Docket Item # 8
BAR CASE # 2012-0259

BAR Meeting
September 5, 2012

ISSUE: After-the-Fact Certificate of Appropriateness &
Waiver of Section 7-202(C) (Fence Height Requirement)

LOCATION: 909 South Saint Asaph Street

Applicant's survey

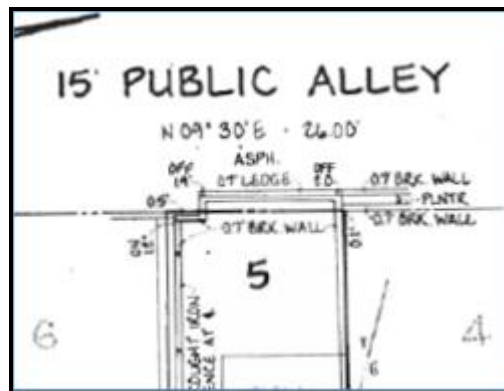
Prior to the recent installation of the four-foot (4') high lattice panel, the site contained a five-foot (5') high, parged masonry wall on a two foot (2') tall retaining wall (11' total, measured from grade on the alley side) however, staff finds no record of either building or BAR permits for the construction of this wall. In addition, it should be noted that the subject portion of the applicant's wall is not constructed on the applicant's property but encroaches into the public right-of-way (ROW), as shown below. T&ES will, therefore, require documentation from the property owner to confirm liability and access for future public work in the ROW.

Staff finds that the general concept of a lattice topped masonry wall complies with the requirements of the *Design Guidelines*. The proposed materials are consistent with other existing walls within this portion of the district, and have no physical impact on historic features. However, staff believes that the proposed four-foot (4') height of the lattice panel is out of scale and inconsistent with the height of other BAR approved lattice panels. Staff recommends that the lattice panels be reduced to two-feet (2') in height. This design will also reduce the overall height of the fence to a total of seven-feet (7') above the interior grade and will enable the new wall's height and configuration to be consistent with other BAR approved wall/lattice combinations within the district. Additionally, prior to obtaining a building permit to install the lattice, the applicant will need to work with T&ES and the City Attorney's office to document the encroachment of the wall in the public ROW.

Staff recommends approval of the Certificate of Appropriateness application and Waiver of Fence Height Requirement with the condition that the lattice panel is reduced in height to two feet above the masonry wall.

Staff recommends that the Board find that the proposed masonry wall is architecturally appropriate and consistent with the character of the district and supports the waiver of Section 7-202(C) to permit two additional feet (2') of wood lattice on top, for a total of 7' above the
